Subject: RE: CNG Hinckley (23/00613/FUL) Update

National Highways Planning Response (NHPR 22-12) Formal Recommendation to an Application for Planning Permission

Proposal: Proposed Bio-CNG vehicle fuelling station comprising fuel dispenser islands, plant compound, landscaping, access, associated highway works and associated development

**DESIGNER'S RESPONSE TO STAGE 1
ROAD SAFETY AUDIT**

Annex B - Plan attached showing the locations of the problems identified as part of this audit.

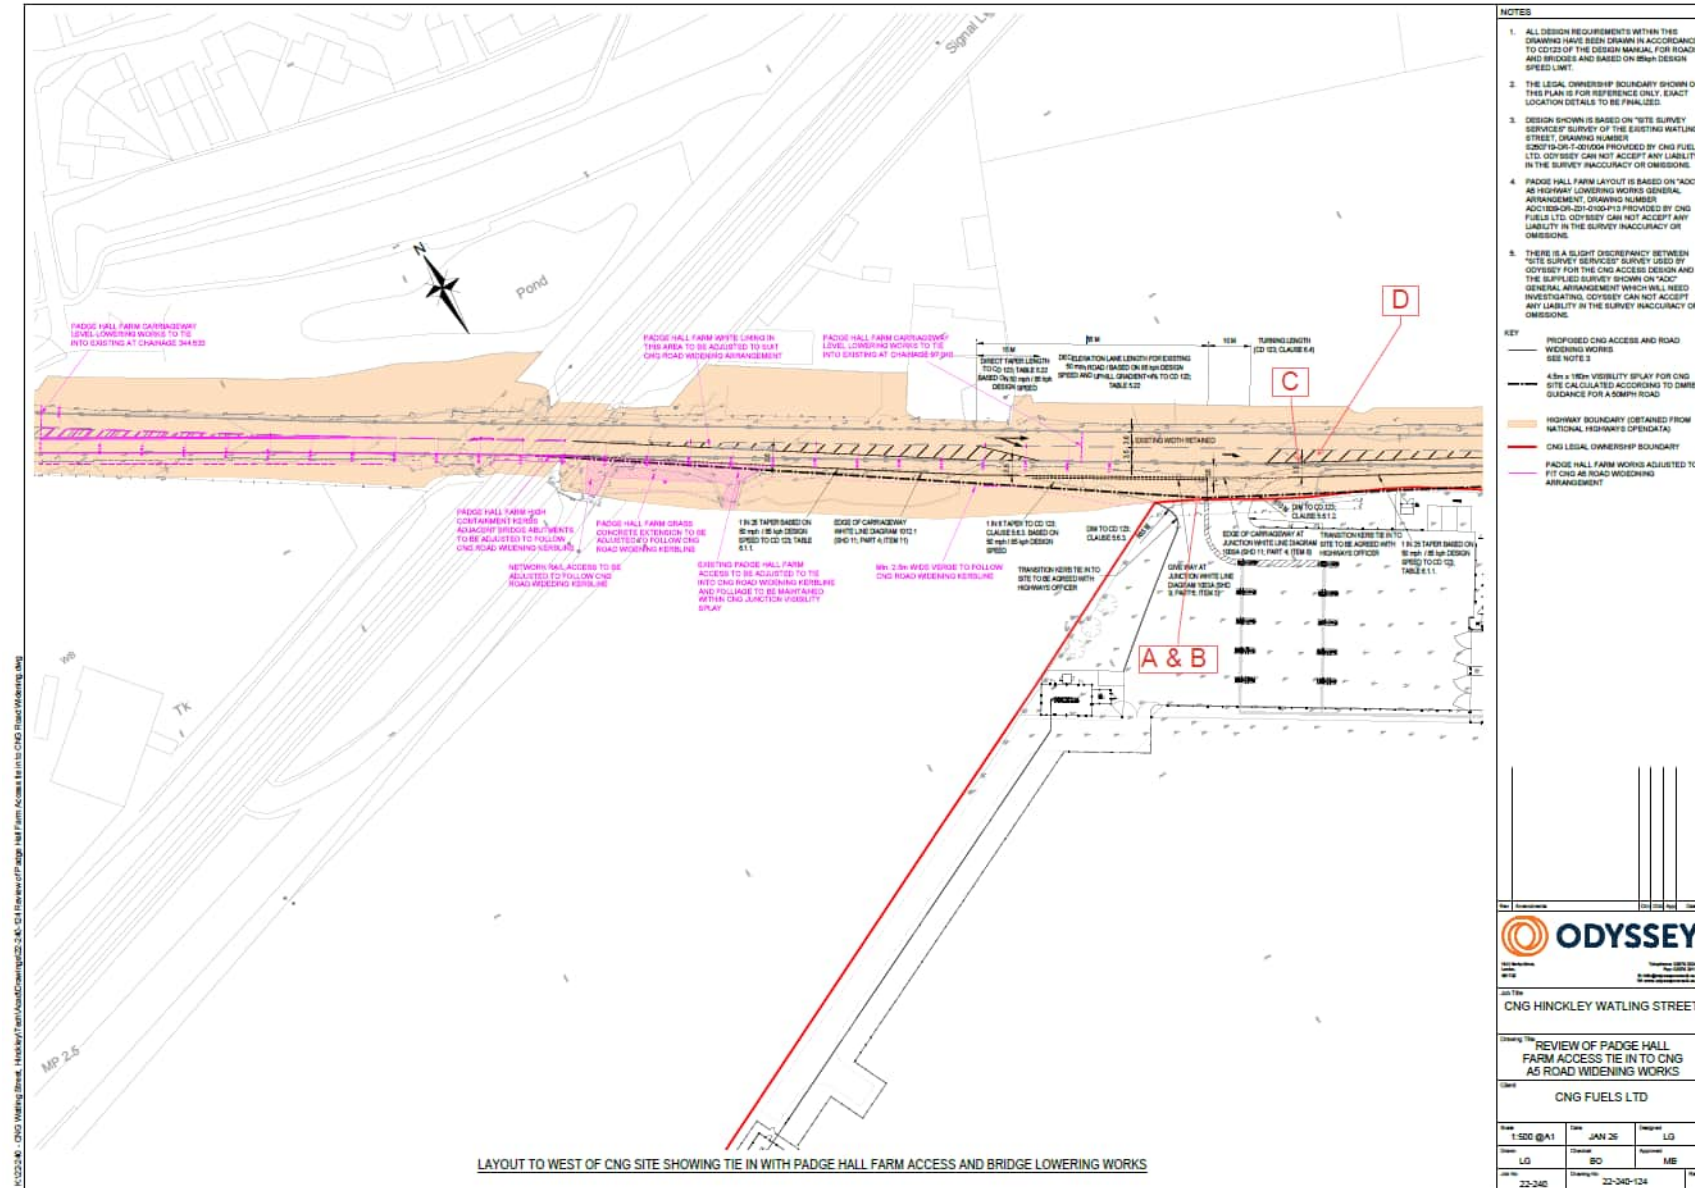
Location: A (Drawing 22-240-124) – At the proposed access to the A5.

The proposed access joins the A5 Watling Street where the surrounding land to the south drops away. It is unclear as to how this change in levels is to be accommodated. A slope could give rise to hill starting issues which could lead to hesitation and require longer gaps in traffic to exit safely, particularly for HGVs or towing vehicles, and could lead to side impact collisions.

Location: B (Drawing 22-240-124) – At the junction of Watling Street and the development access.

Location: C (Drawing 22-240-124) Westbound approach to proposed priority junction, right turn lane.

Location: D – (Drawing 22-240-124) The development.

2.1	Junctions				
2.1.1	Location: A (Drawing 22-240-124) – At the proposed access to the A5. Summary: Potential slope could lead to side impact collisions. The proposed access joins the A5 Watling Street where the surrounding land to the south drops away. It is unclear as to how this change in levels is to be accommodated. A slope could give rise to hill starting issues which could lead to hesitation and require longer gaps in traffic to exit safely, particularly for HGVs or towing vehicles, and could lead to side impact collisions.	It is recommended that the access should be raised to meet the A5 Watling Street with a minimal slope, or that a dwell area should be provided, further, that vertical profile details should be provided at Safety Audit Stage 2.	This is agreed and would be discussed with National Highways/ Leicestershire County Council Highway Officers as part of the Stage 2 RSA.	Designer's response accepted

2.1.2	Location: B (Drawing 22-240-124) – At the junction of Watling Street and the development access. Summary: Restricted visibility could lead to side impact, head on or rear end shunt collisions.	It is recommended that the visibility splay should be unobstructed between the driver's eye heights of 1.05 metres and 2.00 metres to object	This is agreed. The Applicant (CNG Fuels) would be willing to enter into a suitably worded planning condition which safeguards the visibility splays.	Designer's response accepted

2.1.3	Location: C (Drawing 22-240-124) Westbound approach to proposed priority junction, right turn lane. Summary: Insufficient protection of right turning traffic could lead to head on collisions. The proposed junction is in a section of road where a 50mph speed limit applies, and vehicle approach speeds may be inappropriately high. Vehicles waiting to turn right are not protected and should a vehicle inappropriately enter the hatching, this could lead to head on collisions.	It is recommended that a traffic island to the east of the access is installed to protect waiting traffic in the right turn lane.	This recommendation is agreed and the proposed traffic island in accordance with DRMB design requirements, has been shown on revised versions of Drawings 22-240-120, 121, 122, 123, 124 and 125 included in Appendix B.	Designer's response accepted

2.2	Non-Motorised Users (NMUs)				
2.2.1	Location: D – (Drawing 22-240-124) The development. Summary: Local attractor and lack of footway provision could lead to vehicle to pedestrian collisions. The development is adjacent to a fuel station with an associated shop; this may be an attractor for drivers using the CNG facility. There is no pedestrian link between the two sites and pedestrians may choose to walk to the shop at the garage, where it is unlikely that they will cross to the northern footway and then recross. Pedestrians may attempt to use the overgrown verge/walk in the carriageway as this is a relatively short distance. This could lead to vehicle to pedestrian collisions.	It is recommended that a suitable footway link should be provided between the developments.	Disagree. This issue was previously discussed with National Highways/ Leicestershire County Council Officers (at the pre-application stage for the previously consented application), whereby Odyssey advised that none of CNG's operational sites provide HGV vehicle waiting facilities (outside of refuelling), as this would impact the operation of the sites and could result in additional highway safety issues with vehicles potentially blocking the site access. For operational purposes, CNG operates a policy of not permitting any waiting on their sites, with the exclusion of refuelling. Any users found to be not adhering to this policy would be contacted and reminded of the policy. If	Designer's response accepted

Drawing Title
DMRB REVIEW OF RIGHT TURN LANE ON WATLING STREET

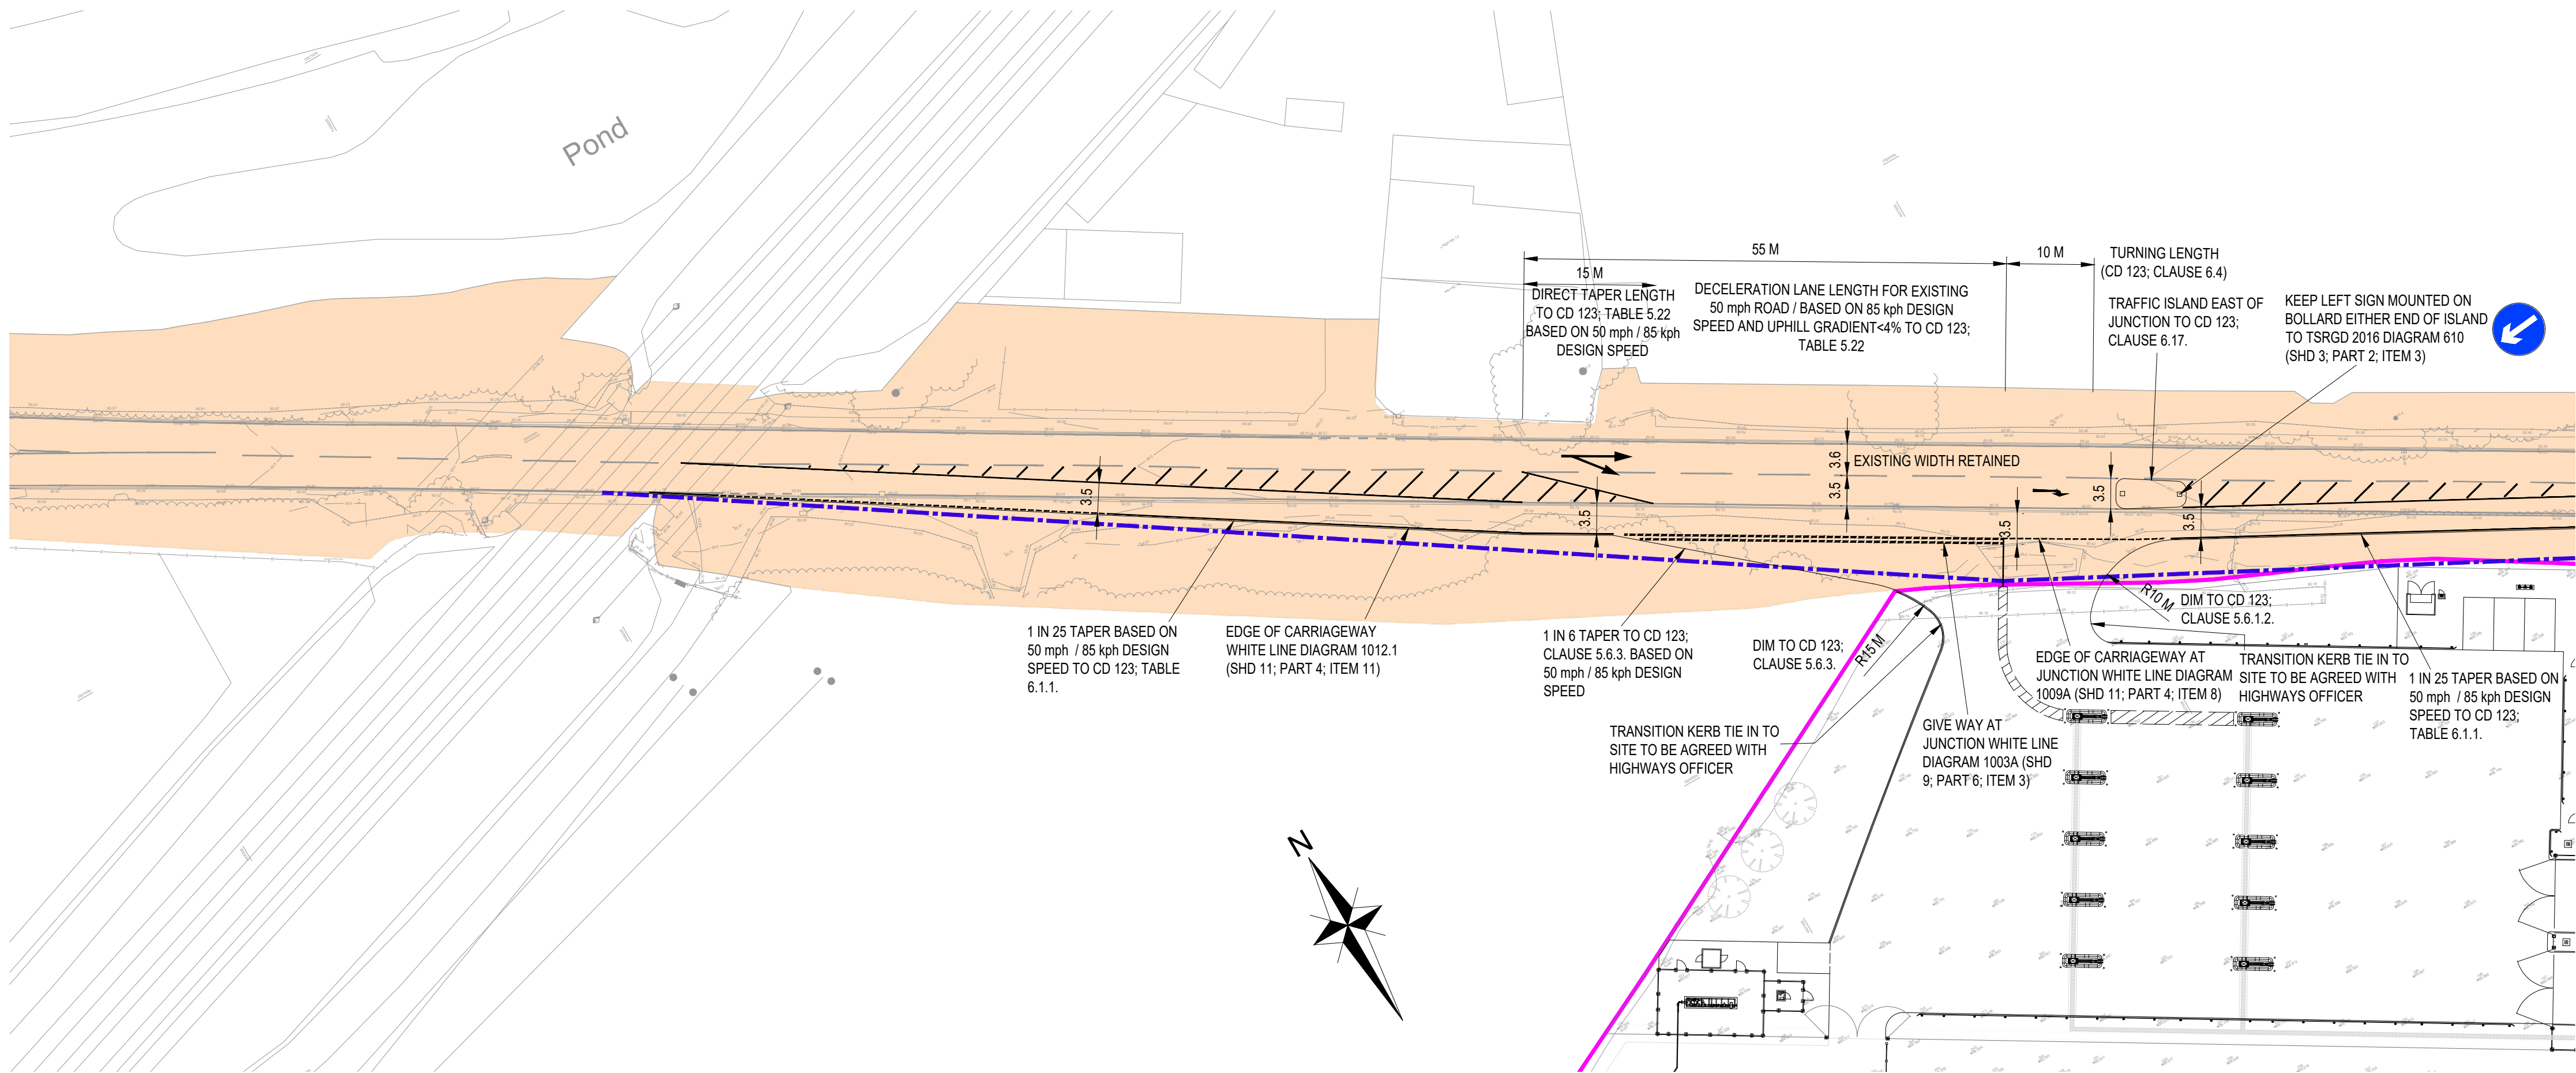
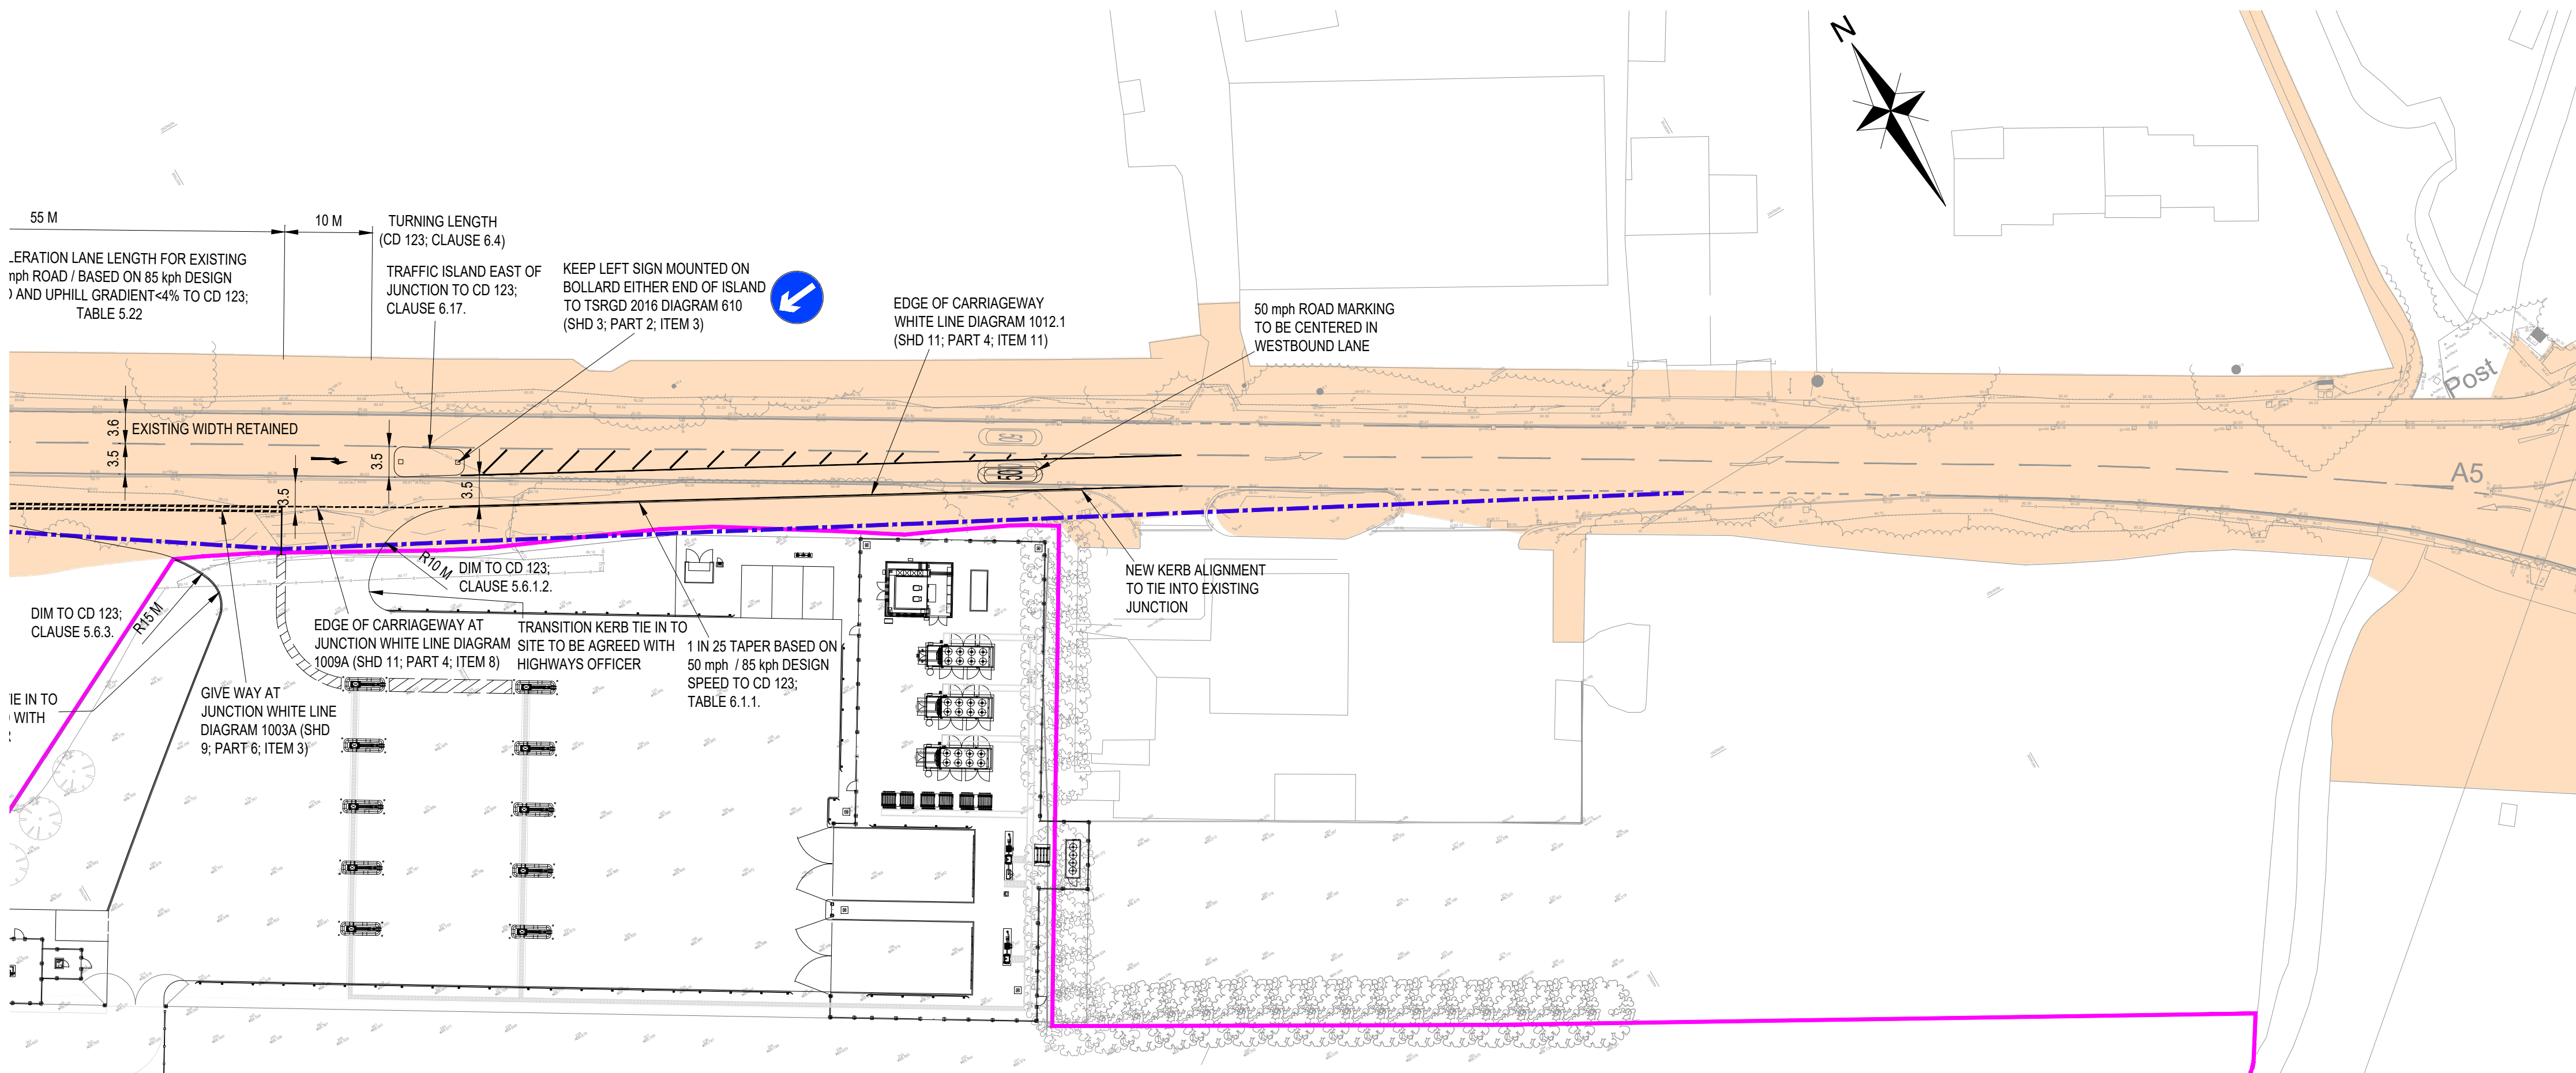
E	TRAFFIC ISLAND ADDED EAST OF SITE ENTRANCE FOLLOWING RSA1 COMMENTS	LG	BO	MB	29.04.26
D	SITE LAYOUT UPDATED TO CNG LATEST DESIGN	LG	BO	MB	05.12.25
C	JUNCTION RADII KERBS AMENDED FOLLOWING NATIONAL HIGHWAYS COMMENTS	LG	BO	MB	27.11.25
B	JUNCTION REDESIGNED TO REFLECT LATEST SITE LAYOUT RECEIVED 24-11-25 FROM CNG	LG	BO	MB	24.11.25
A	JUNCTION REDESIGNED TO UPDATED TOPO SURVEY INFORMATION RECEIVED 26.09.25 AND TO CD 123 BASED ON 85kph DESIGN SPEED	LG	BO	MB	21.11.25
